UNITED STATES PATENT AND TRADEMARK OFFICE

APPLICATION NO.	FILING DATE	FIRST NAMED INVENTOR	ATTORNEY DOCKET NO.	CONFIRMATION NO.
09/681,545	04/26/2001	Dennis P. Bobay	03-DV-7090	9760

## Office Action Summary

as shown in Figure 25.

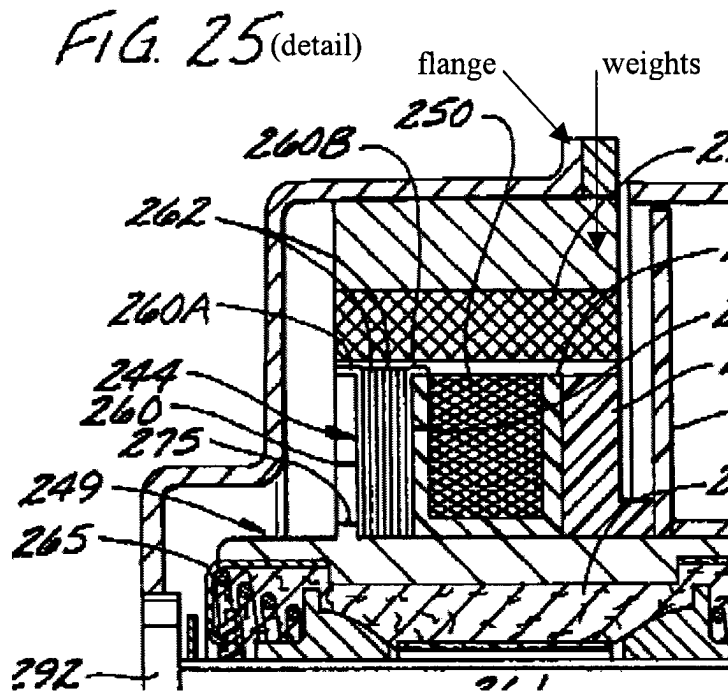
10. With regards to claim 6, 7, 9 and 10 Hollenbeck et al. discloses a rotor cup assembly, wherein:

said annular flange is configured to have an edge, said edge outwardly flared from said sidewall by an angle  $\Phi$ ;

said annular flange configured to receive a plurality of weights (added by the examiner) to facilitate a desired level of rotor balance;

said annular flange second diameter greater than said housing sidewall first diameter;

said annular flange provides a smooth surface for pressing an item into said rotor cup;
